# ***Interactive comment on* “Stress field orientation controls fault leakage at a natural CO<sub>2</sub> reservoir” by Johannes M. Miocic et al.**

**Johnathon Osmond (Referee)**

My review comments for manuscript se-2020-12 written by Miocic and others are described herein. The authors present a body of work set on addressing how stress field orientation influences natural leakage along faults by combining geomechanical modelling of a particular fault bounding a natural subsurface CO<sub>2</sub> accumulation with outcrop information. Although the methods and framework are not novel, the main idea communicated by the authors is that CO<sub>2</sub> leakage occurred mainly along the northern tip of the analyzed fault, which coincides with the location of travertine deposits as well as areas of high fault slip tendency and fracture stability modeled along the fault zone using three potential stress fields derived from regional measurements. The authors go on to discuss the importance of valid stress orientation parameters in relation to CO<sub>2</sub> stor-

Fig. 1.

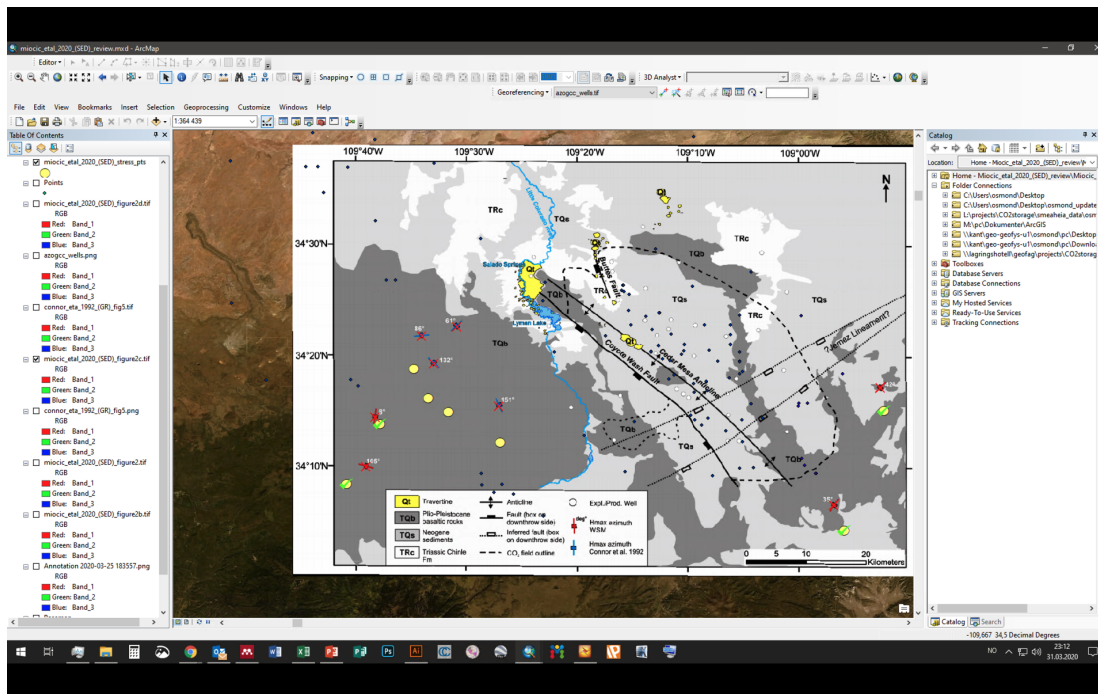
- SHmax measurement locations were cross-checked with their mapped pattern in Figure 2. The pattern for the set of 8 points appears to agree with what is shown in Figure 2 except for point ID 4 (SHmax=61 deg, Connor et al., 1992), which plots much further south than what is indicated in Figure 2. This means that either the mapped location in Figure 2 is correct or the location from Table 1 is correct. Point coordinates were then checked based on their sources. WSM points from Heidbach et al. (2016) were validated, but those from Connor et al. (1992) were not. It was not clear from Connor et al. (1992) where the authors of se-2020-12 obtained both their SHmax azimuths and coordinate locations in Table 1. Could it be that the data was sourced from an alternative data repository? Two suggestions to the authors here include addressing the discrepancy between Table 1 and Figure 2 locations for point ID 4, and describing the origin/location of the measurements derived from Connor et al. (1992) in greater detail.

- The figures in the manuscript are generally of good quality. While some minor adjustments could be made to Figure 2, several mapping errors were recognized after trying to georeferenced the map using the coordinate grid along its border. This was evident after plotting the SHmax points provided in Table 1 (aside from point ID 4 mentioned above), as the points on the map did not line up with the plotted points using the coordinates (see attached images for this review). WSM SHmax coordinates in Table 1 were verified with Heidbach et al. (2016), while points from Connor et al. (1992) could not be verified by reviewing the cited publication. If the Figure 2 map is georeferenced based on the WSM points, the map is distorted and the location of features (like Lyman Lake) do not align with satellite imagery. The same can be said if the Figure 2 map is georeferenced based on the Connor et al. (1992) points. The geographic features do

Fig. 2.

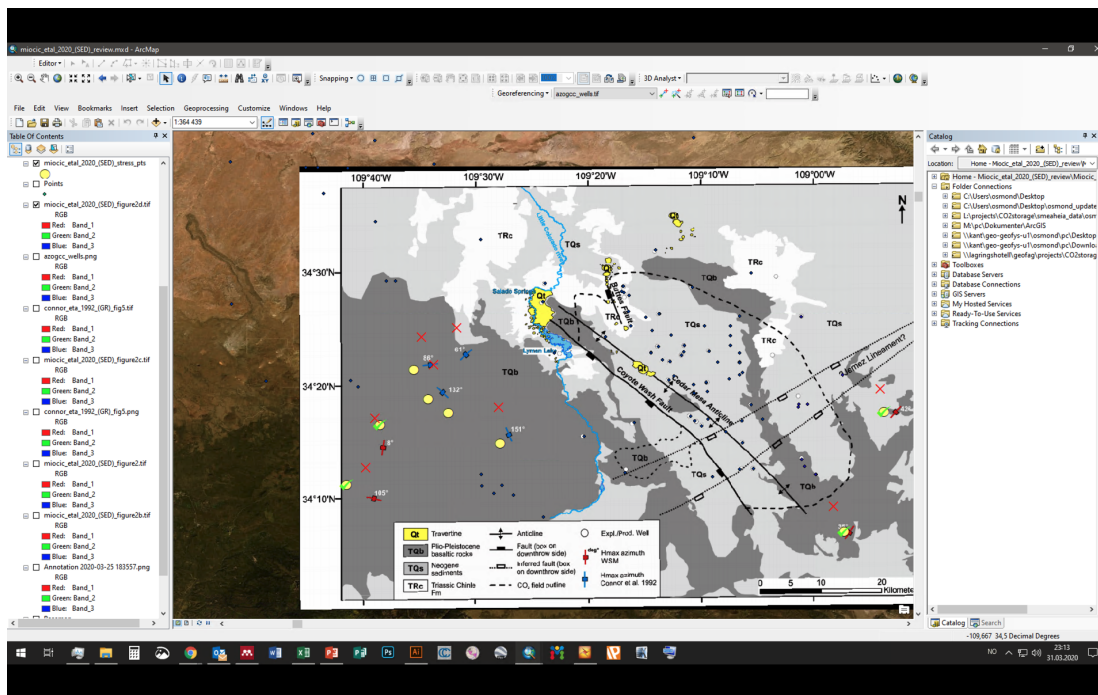
align with satellite imagery if the map is georeferenced to the well locations (I obtained the well locations using ArcMap online data searching Arizona oil and gas wells). However, even though Lyman Lake and other features are aligned, the SHmax points on the map still don't match the points plotted using Table 1 coordinates. Since all the data should agree, it is suggested that the coordinates along the outside of the Figure 2 map and the Table 1 SHmax coordinates are reviewed compared to the geography from the satellite imagery and the well locations. Any errors or reference system discrepancies should be corrected in the manuscript. Furthermore, it is suggested that additional culture data, such as state boundaries or highways, are added to the map.
